**GOVERNMENT OF CANADA
MULTI-PURPOSE TRAINING FACILITY MECHANICAL RENOVATION
REGINA, SASKATCHEWAN**

**NUMBER TEN ARCHITECTURAL GROUP
310 - 115 BANNATYNE AVENUE
WINNIPEG, MB R3B 0R3**

<u>Contents</u>	<u>No. of Pages</u>
Addendum No. 1	3
<u>Attachments:</u>	
▪ Revision Drawing RA-1	1

project GOVERNMENT OF CANADA
Multi Purpose Training Facility
REFER TO A1.2
ROOM 106 DOOR AND WALL
sheet title

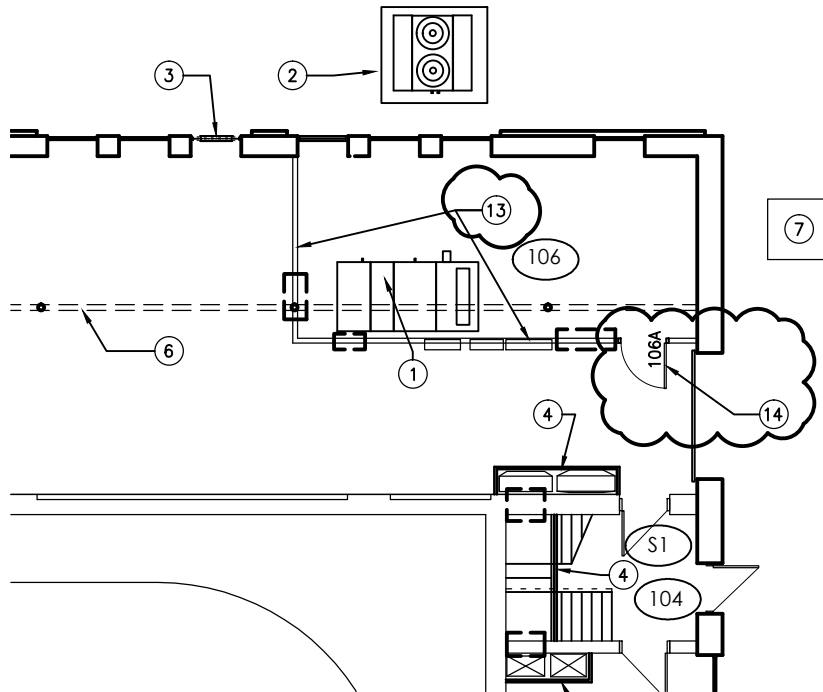
.1 Room 106: Demolish existing demising wall and door and replace with new ULC W453 1 hour rated wall, complete with new fire rated door and frame D106A. Refer to RA-1

- ⑬ DEMOLISH EXISTING WALL.
NEW ULC W543 1 HR RATED WALL. 16 TYPE-X DRYWALL ON BOTH SIDES OF 152 STEEL STUDS. PAINT AND NEW RCB.
- ⑭ DEMOLISH EXISTING DOOR AND FRAME. REPLACE WITH NEW 3/4 HR RATED HOLLOW METAL DOOR AND FRAME. PAINT.
